PAINT BRUSH HILLS FILING NO. 14

PROJECT NO. 10-014 DATE: 03/19/2021
SCALE: N/A HORIZONTAL: N/A VERTICAL: N/A
DESIGNED BY: JWP
DRAWN BY: JWP
CHECKED BY: GW

STREET IMPROVEMENT PLANS

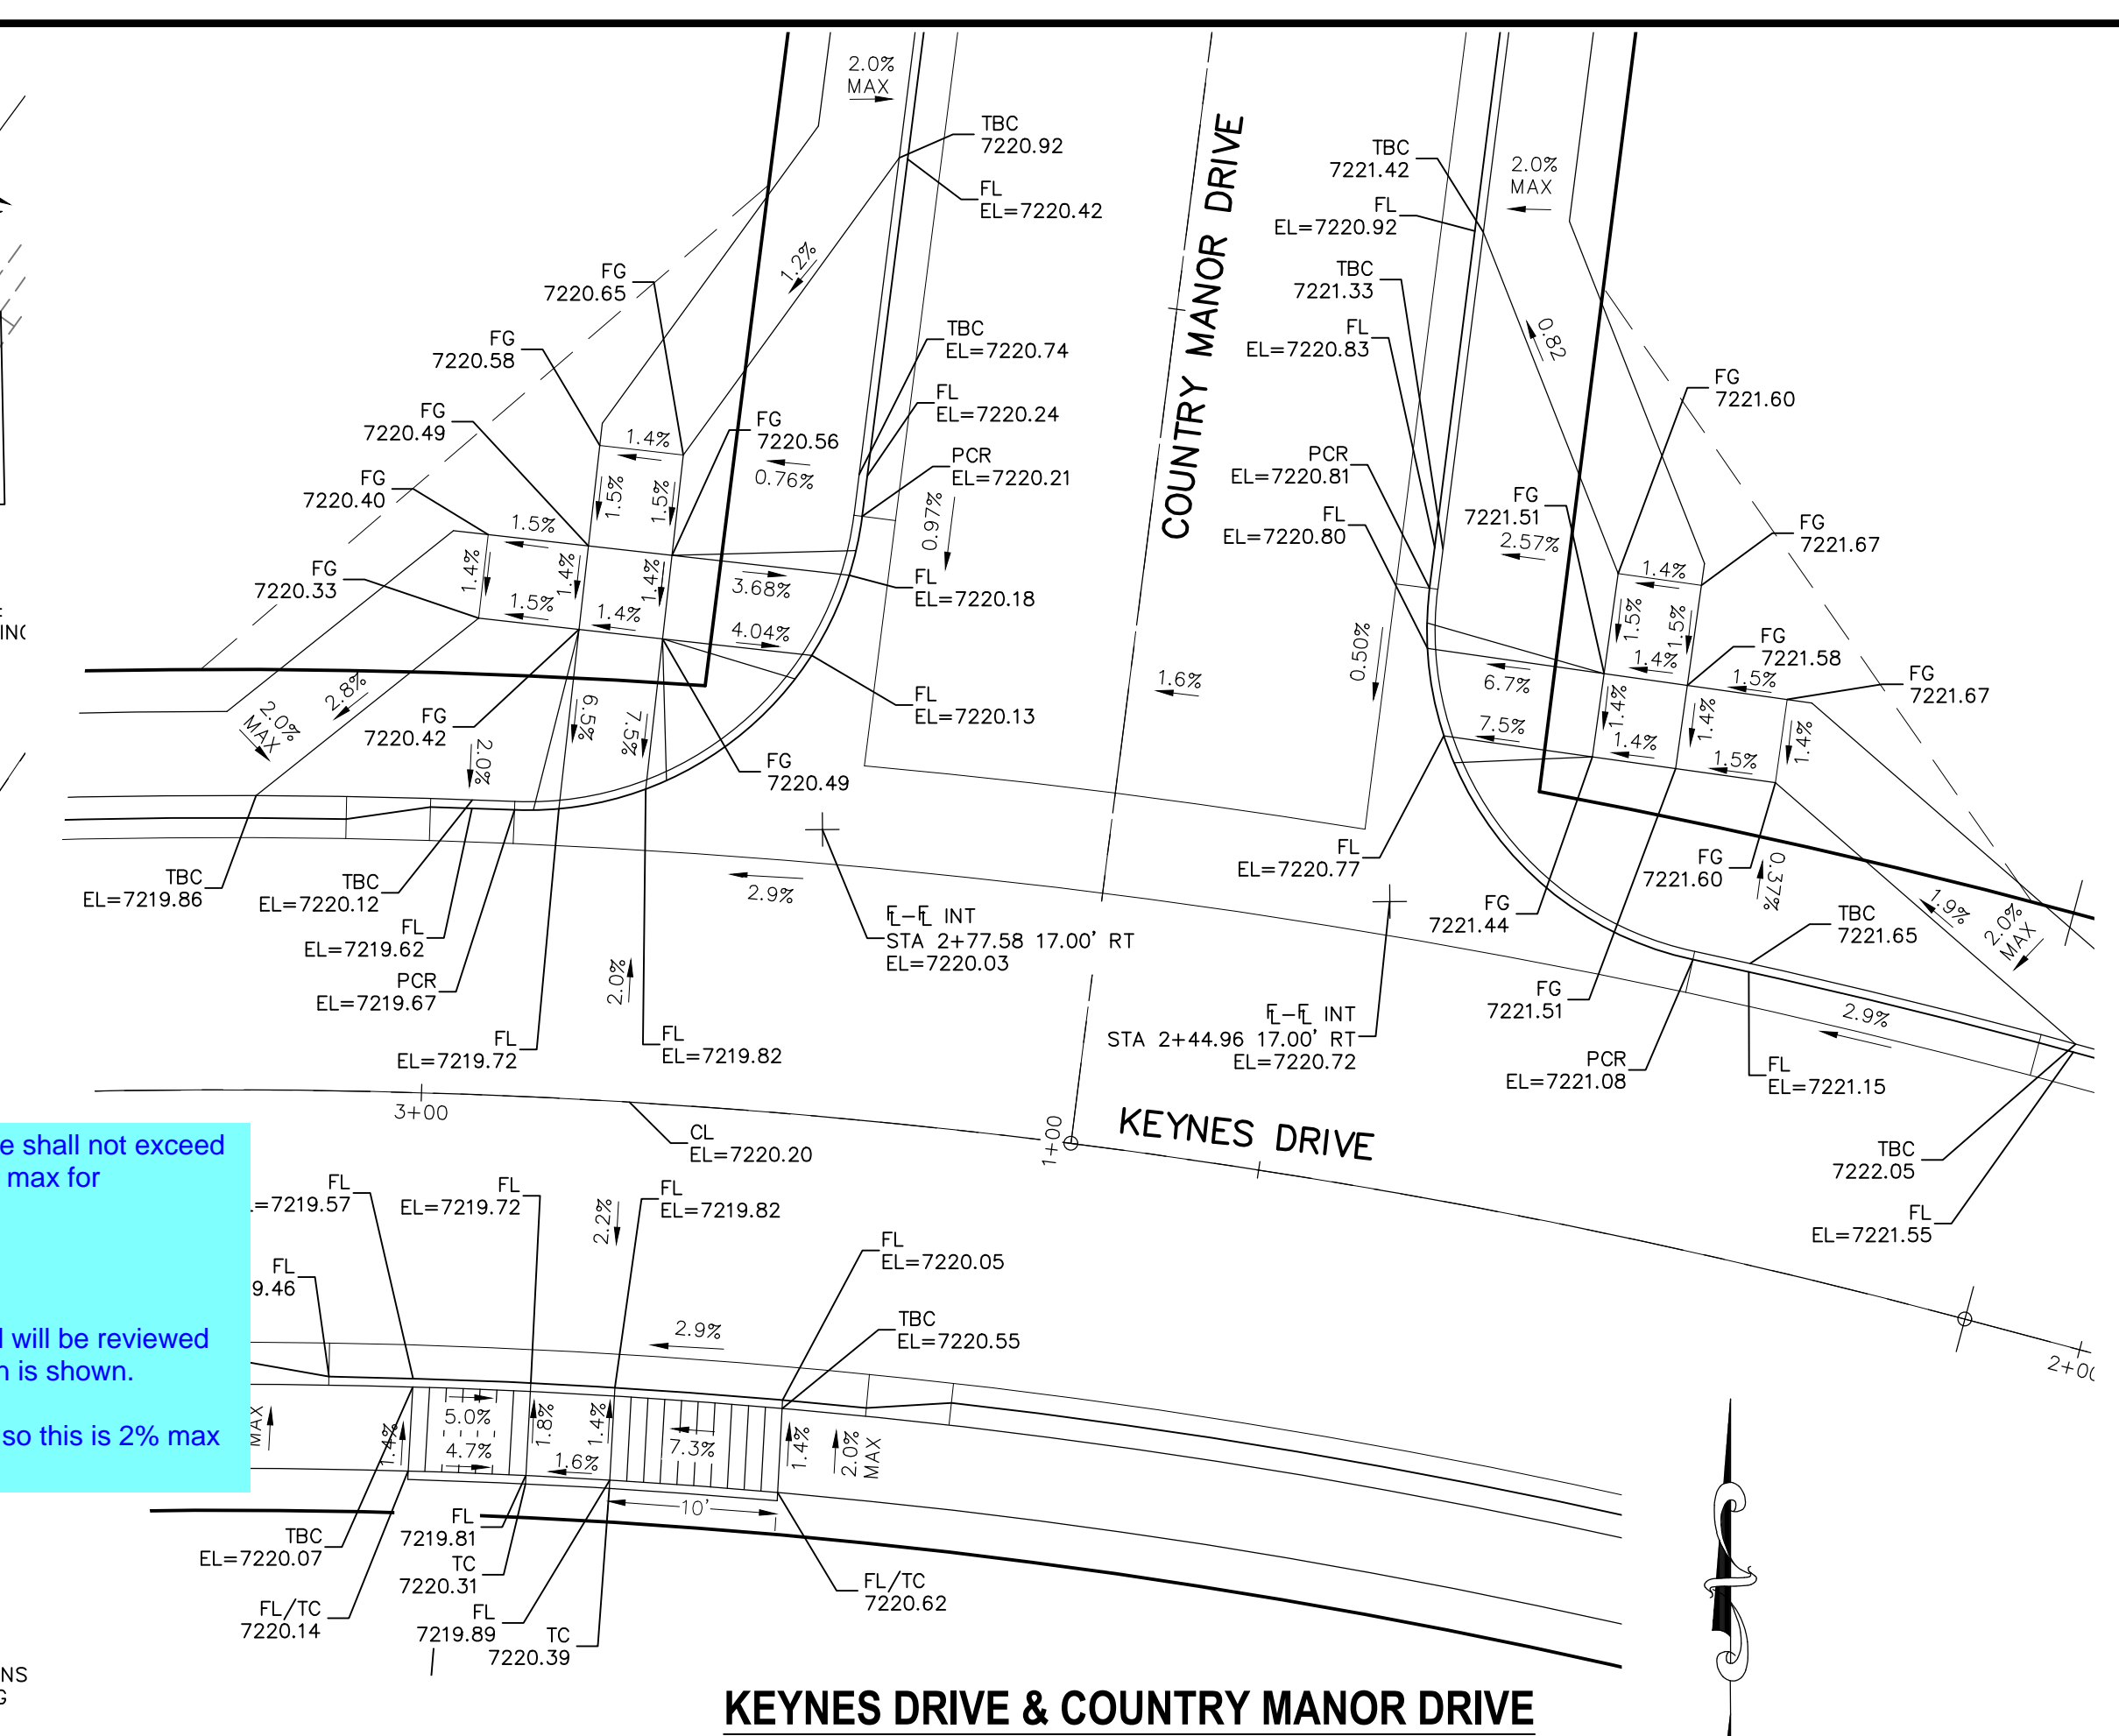
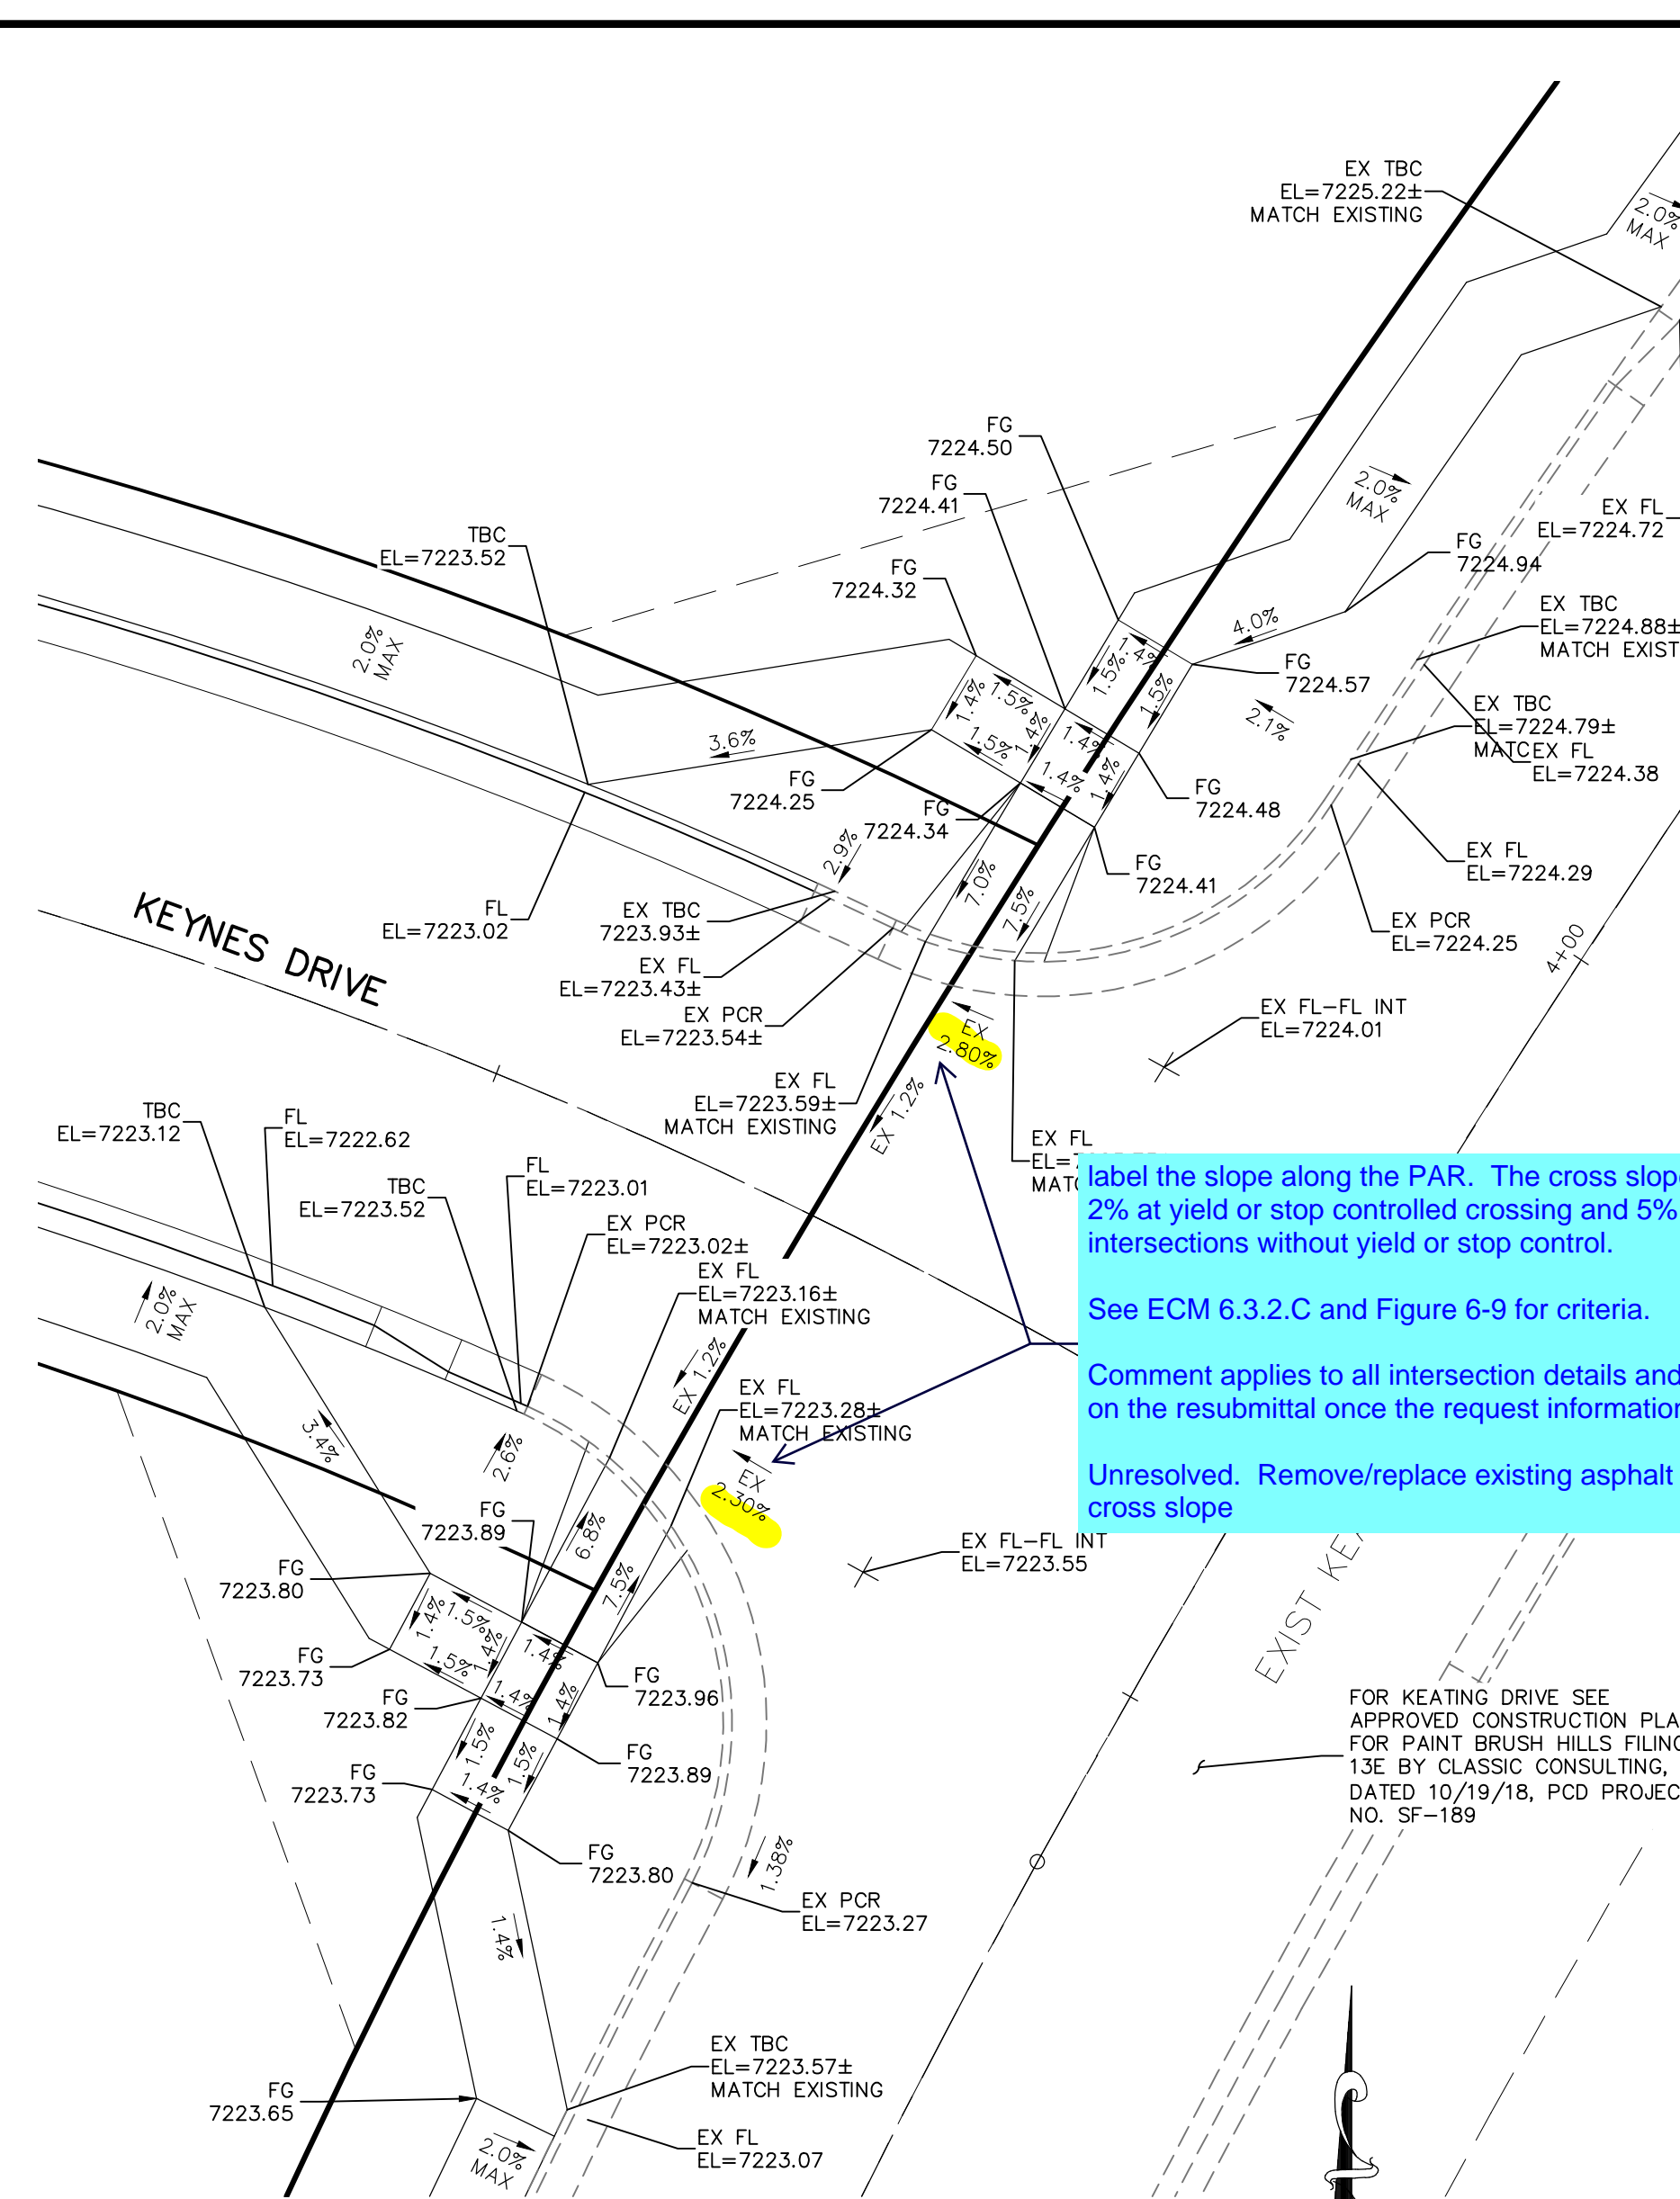
Label the slope along the PAR. The cross slope shall not exceed 2% at yield or stop controlled crossing and 5% max for intersections without yield or stop control.
See ECM 6.3.2.C and Figure 6-9 for criteria.
Comment applies to all intersection details and will be reviewed on the resubmittal once the request information is shown.
Unresolved. Remove/replace existing asphalt so this is 2% max cross slope
